Access Compliance Report

Public Rights-of-Way

Intersection ID: 46324	Main Street: ARBOR_VISTA_DR	Cross Street: SENATOR_ROYALL_DR	Location: SW
ADA ID: 957234257DE4	Ramp Type: PerpDiag	Initial Pass/Fail: Fail	Overall Compliance: No
Severity Score: 8.75			
Codes/Mitigation Info/Possible Solution		Field Measurements/Component Compliance

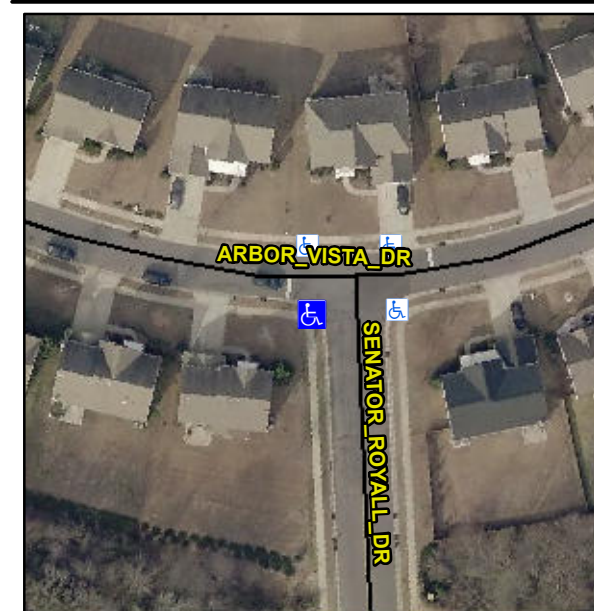
Not Found, R304.5.1

Compliance	Description	Data	Compliance	Description	Data
N/A	Ramp Length (in)	49.0	Yes	Ramp Slope (%)	5.7
No	Ramp Width (in)	43.5	Yes	Ramp XSlope (%)	0.6
N/A	Flare Type LT	N/A	N/A	Flare Type RT	N/A
N/A	Flare Slope LT (%)	N/A	N/A	Flare Slope RT (%)	N/A
N/A	Flare Traversable LT?	N/A	N/A	Flare Traversable RT?	N/A
N/A	Landing Length (in)	N/A	N/A	DWS Provided?	N/A
N/A	Landing Width (in)	N/A	N/A	DWS Contrast?	N/A
N/A	Landing Slope (%)	N/A	N/A	DWS Length (in)	N/A
N/A	Landing X Slope (%)	N/A	N/A	DWS Full Width?	N/A
N/A	Landing Curb? (Y/N)	N/A	N/A	DWS Offset (in)	N/A
N/A	Shared Landing?	N/A			
N/A	Gutter Ponding?	N/A	N/A	Gutter Slope (%)	N/A
N/A	Gutter Lip Ht (in)	N/A	N/A	Gutter X Slope (%)	N/A
N/A	Painted X Walk1?	No	N/A	Painted X Walk2?	No
	X Walk 1 Direction	To N		X Walk 2 Direction	To E
N/A	X Walk 1 Width (in)	N/A	N/A	X Walk 2 Width (in)	N/A
	X Walk 1 Slope (%)	2.6		X Walk 2 Slope (%)	3.1
	X Walk 1 X Slope (%)	1.9		X Walk 2 X Slope (%)	1.1

Remove & Replace Curb Ramp With Two New Directional Ramps or Equivalent.
